Exhibit “B”

Memo

Subject: Engineering Comments for Land Use Application for Proposed Retail on SE Corner of 1st and Baseline

By: Terry, Keyes, P.E., City Engineer

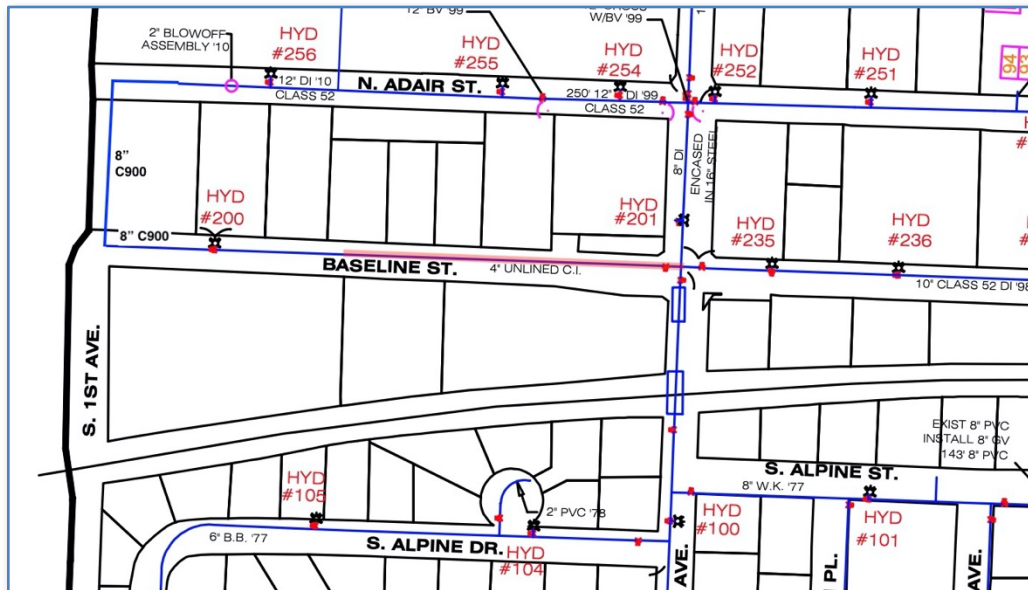
The frontage along 1st is improved with a concrete curb and gutter and a concrete curb-tight sidewalk. Two driveway drops exist along this frontage. The applicant proposes to replace the northern driveway drop with standard curb/gutter and sidewalk which the city would require. The existing southern driveway is proposed to be used as the access point from S. 1st Avenue to the site. This is acceptable to the city.

Street lights are mounted on PGE power poles on the west side of S. 1st Avenue. No overhead power lines exist on the east side of the 1st.

The applicant proposes street trees along S. 1st Avenue meeting the requirements of the City's Public Works Standards.

No other frontage improvements on S. 1st Avenue are required for this project.

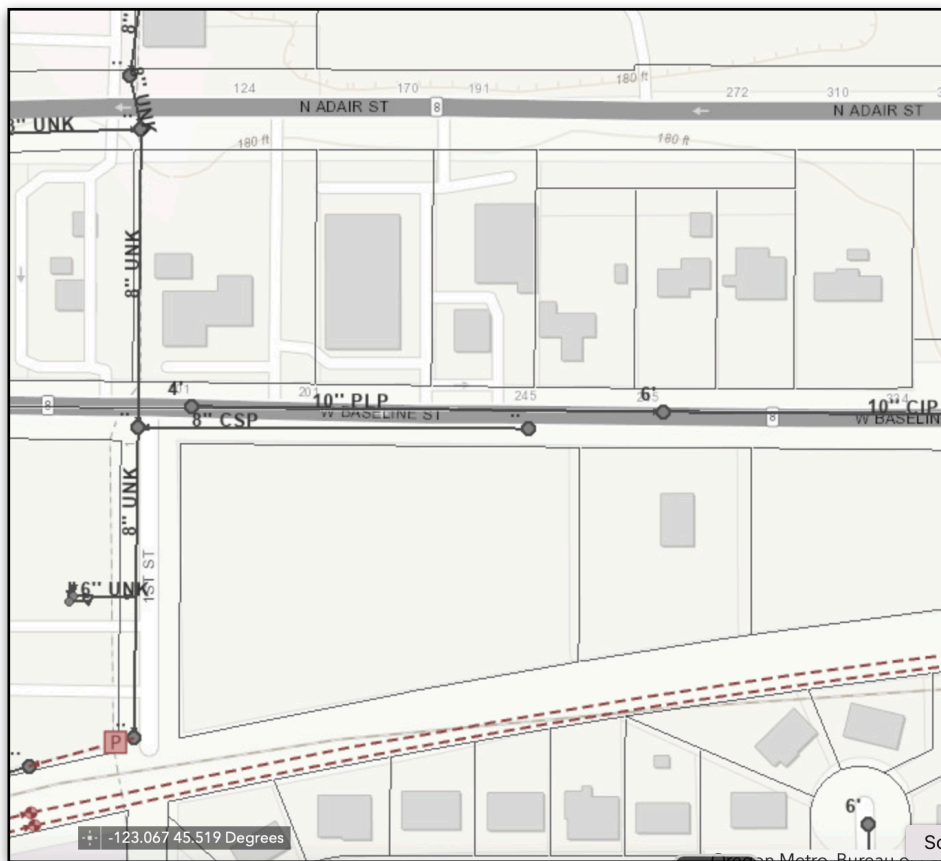
A variety of sanitary sewers surround the site as shown in the drawing below. Along the Baseline frontage and on S. 1st Avenue is an 8" public sanitary sewer. This sewer primarily serves Forest Grove and goes to a pump station at S. 1st Avenue and the railroad. This 8" line and the system it is connected to do NOT have capacity for the site.

A 10" public sewer exists on the north side of Baseline and drains to the east. This line does have capacity for the site. Therefore, the site shall connect to the 10" main flowing east in Baseline. The preliminary plans show this connection.

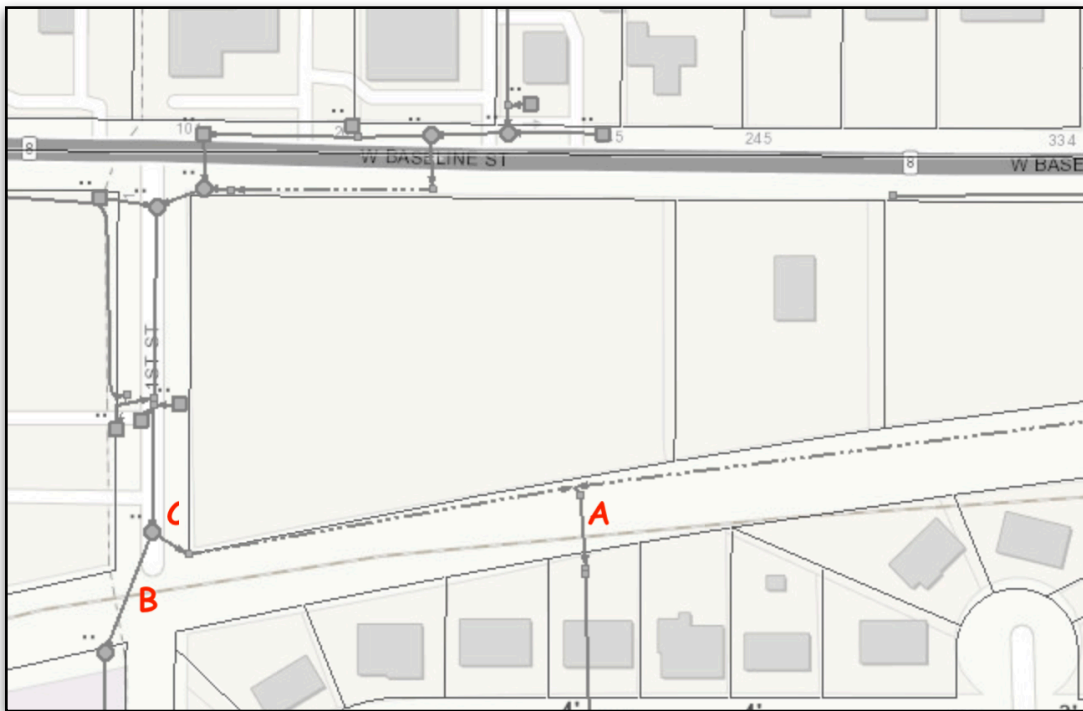
Before Walmart was constructed 14 years ago, stormwater runoff in the basin north of the railroad all flowed through a single culvert under the railroad. This is shown as point A in the drawing below. This routing of stormwater caused periodic flooding problems in the downstream neighborhood because the system lacks the capacity for handling all the runoff north of the railroad.

To deal with the additional stormwater flows from the Walmart site north of Adair, Walmart constructed a stormwater bypass pipe from the railroad to Heather Street along the Cornelius/Forest Grove boundary. The bypass goes under the railroad at point B. A control manhole at point C allows the city to split stormwater flows between the two routes under the railroad. Over the past 14 years, this system has successfully eliminated flooding in the neighborhoods to the south.

The applicant's preliminary stormwater plan routes the majority of runoff into the bypass system near manhole C. A portion of the site runoff is routed directly into the wetland area at point A. With the proposed detention provided for site runoff, this arrangement of discharges is acceptable and should not overburden the storm system south of point A.
